Determination 2020/008

The refusal to issue a code compliance certificate for a 20-year-old house with monolithic cladding at 60 Godley Lane, Albany, Auckland

Figure 2: Approximate site plan

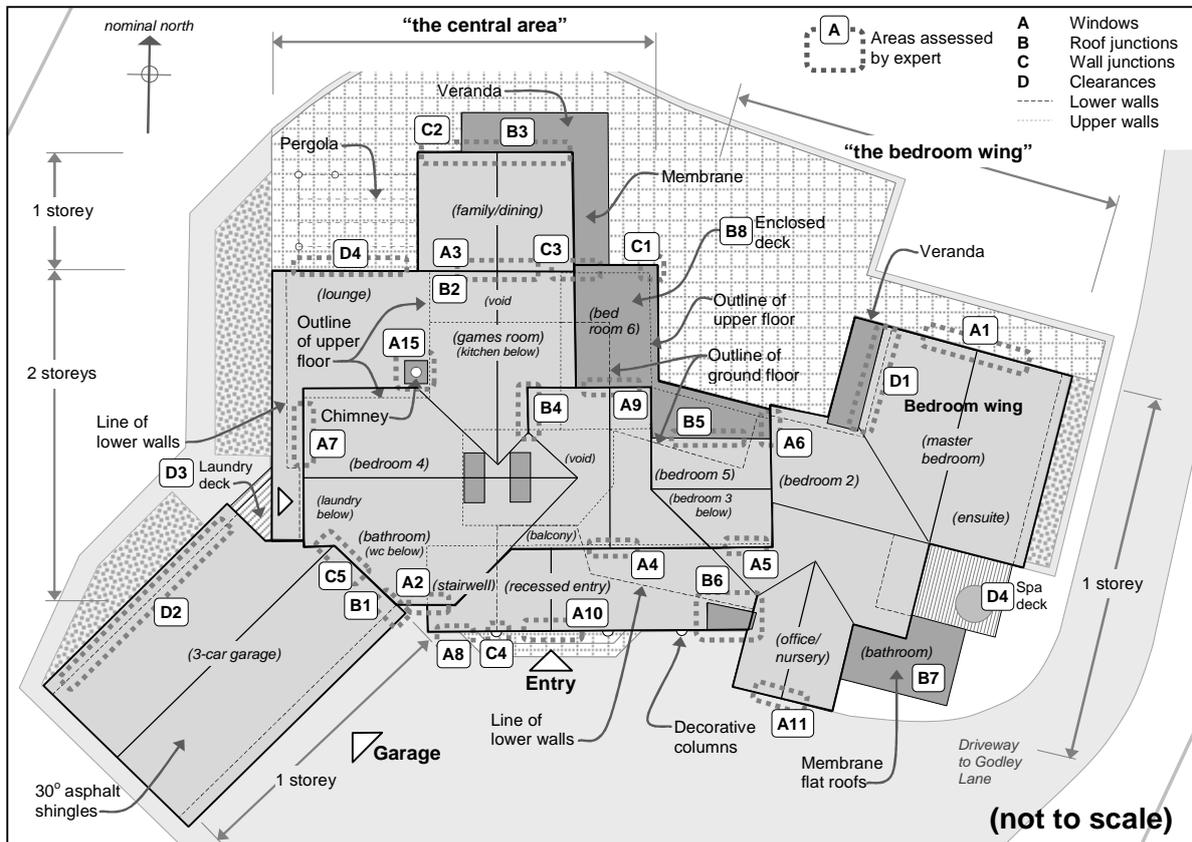
5.3.2 Most readings varied from 8% to 15%. However, elevated readings or signs of damage were recorded as follows (with locations as per Figure 2 shown in brackets):

- 13%, but decayed drillings below window jamb to Bedroom 1 (Area A1)
- 20% to 21% below window jamb to lower toilet (Area A8)
- 22% below the garage/toilet roof junction (Area B1).

5.3.3 The expert carried out further investigation of the following areas (refer Figure 2):

- At the north window to Bedroom 1 (Area A1):
 - linings were removed below the west jamb to investigate the underlying framing, revealing visible decay to the outer part of a stud

Figure 3: Typical window installation (as provided with the determination application)

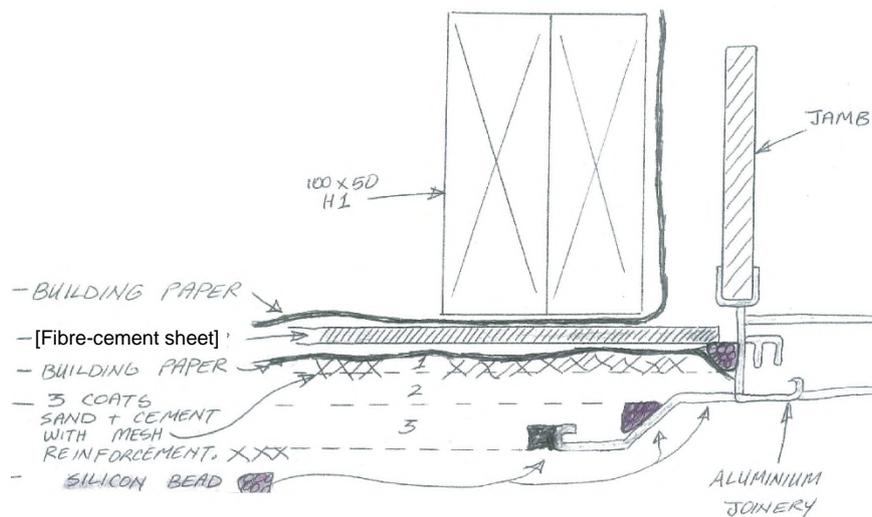
- 4.2.5 On 16 August 2019 the authority accepted the first draft subject to the following comments (in summary):
- The typical window jamb detail (Figure 3) was a critical junction ‘which could potentially cause damage to every elevation of the building’ particularly as there are no sill flashings. Deconstruction of a sample of these junctions was required to determine performance.

- In regard to the lack of sill flashings:
 - the lack of sill flashings increases reliance on sealant
 - the sill detail appears similar to the jamb detail shown in Figure 3 (where the position of the decorative sill band is indicated by the dotted line)
